ACCESSION NBR: 8006050540 DOC. DATE: 80/06/02 NOTARIZED: NO DOCKET #
 FACIL: 50-397 WPPSS Nuclear Project, Unit 2, Washington Public Powe 05000397
 AUTH. NAME AUTHOR AFFILIATION
 RENBERGER, D.L. Washington Public Power Supply System
 RECIP. NAME RECIPIENT AFFILIATION
 Office of Nuclear Reactor Regulation
 YOUNGBLOOD, B.J. Licensing Branch 1

SUBJECT: Forwards responses to Questions 360.004 & 360.005, open items from round 1, Set 2. Questions will be incorporated in FSAR, Amend 10. References, prepared by Shannon & Wilson & Woodson-Clyde Consultants, will be forwarded.

Subject: WPPSS NUCLEAR PROJECT NO. 2
RESPONSES TO ROUND ONE QUESTIONS
OPEN ITEMS FROM SET TWO -
GEOSCIENCES BRANCH (GSB)

WPPSS NUCLEAR PROJECT NO. 2
RESPONSES TO ROUND ONE QUESTIONS
OPEN ITEMS FROM SET TWO -
GEOSCIENCES BRANCH (GSB)

FIGURE
1

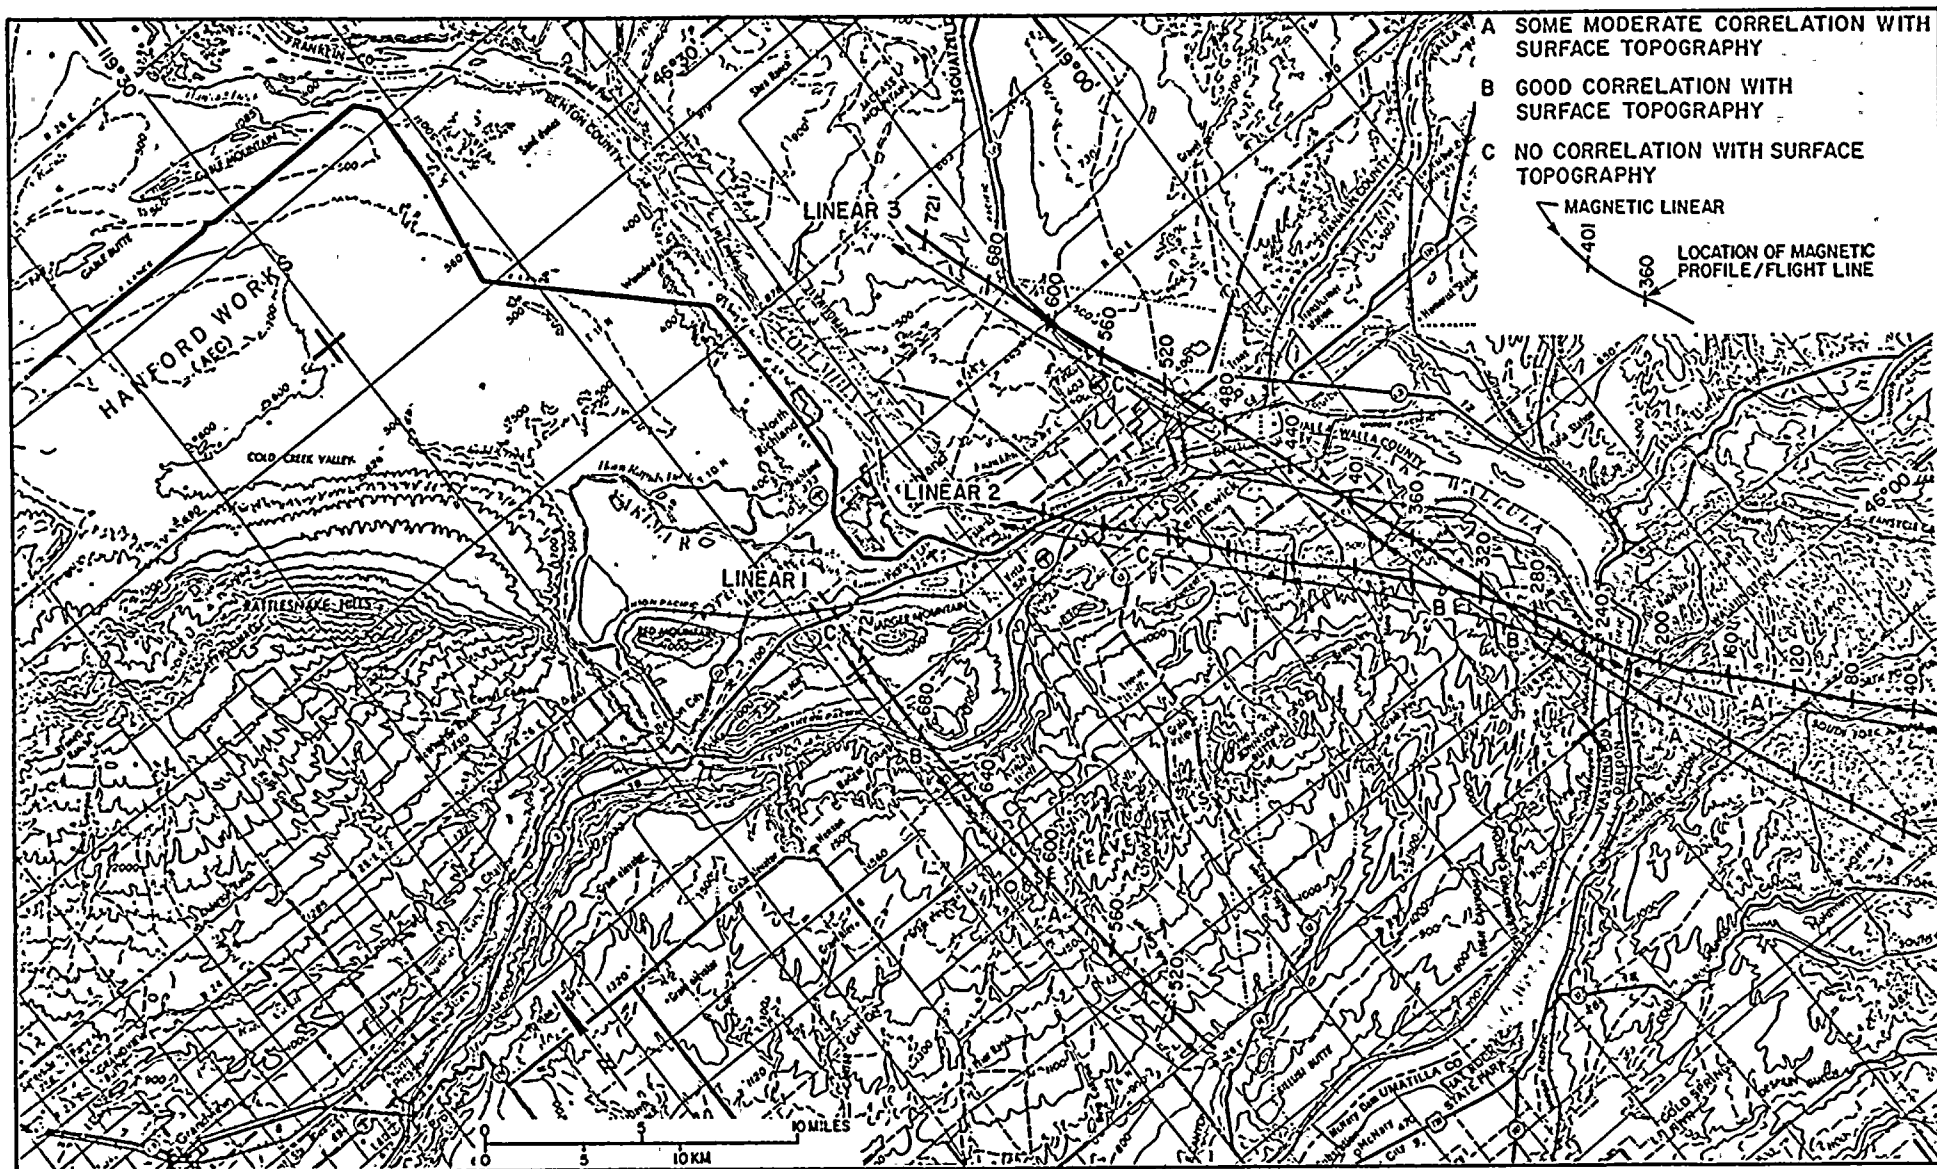
"In the Weston Geophysical Research, Inc., report, "Qualitative Aeromagnetic Evaluation of Structures in the Columbia Plateau and Adjacent Cascade Mountain Area," March 28, 1978, Figure 13 shows several north to northwest-trending aeromagnetic linears in the vicinity of Badger Mountain and Jump Off Joe Anticline. However, the Weston report does not discuss the origin or interpretations of these particular linears. The north-trending linear crossing the Columbia River at the junction with the Snake River has an apparent offset of the magnetic low defining the Rattlesnake Hills anomaly. Since these aeromagnetic linears trend toward the WNP-2 site, provide: (1) an interpretation of these features, including but not limited to the potential for their continuation of the north to the near site area; and (2) a discussion of the fault parameters, if such an interpretation is proposed."

The location of the four profiles relative to the three linears referred to in Question 360.4 is shown in attached Figure 360.4-8. The results of the modeling for profiles 360, 450, 510 and 570 are shown in attached Figures 360.4-9 through 360.4-12.

Profiles 370, 450 and 510 cross aeromagnetic linears 2 and 3, Question 360.4; the Kennewick-Cold Creek linear identified by C. E. Glass, page 2R K-10, Amendment 23, WNP-1/4 PSAR; the Rattlesnake-Wallula trend; and Zintel Canyon. No aeromagnetic anomaly can be observed on profile 370 or 450 in the vicinity of the intersect with the Kennewick-Cold Creek linear. On profile 510, an aeromagnetic anomaly does occur within approximately 5000' of the projected location of the Kennewick linear. Attempts to model this anomaly as a fault, assuming various offsets between 50' to 200' with a fault plane dipping between 45° NE and 70° SE, were unsuccessful. It is Weston's opinion that this anomaly probably represents an erosional feature in the basalt surface.

An aeromagnetic anomaly that is coincident with the Zintel Canyon fault, shown on Figure 2R H.5.1, Amendment 23, WNP-1/4 PSAR, can be observed on profiles 370, 450 and 510. This anomaly was successfully modeled as a fault, assuming 200' and 300' offsets and a vertical dipping fault plane.

The Rattlesnake-Wallula trend of aeromagnetic anomalies was successfully modeled as a fault on all four profiles with 200' of offset assumed on profiles 370, 450 and 510, and 100' of offset assumed on profile 570. All profiles were modeled as a vertical fault with the northeast side down. Results of the modeling of profile 570, Figure 360.4-12, are incomplete at this time for the southwest portion where the profile intersects aeromagnetic linear 1, referred to in Question 360.4.
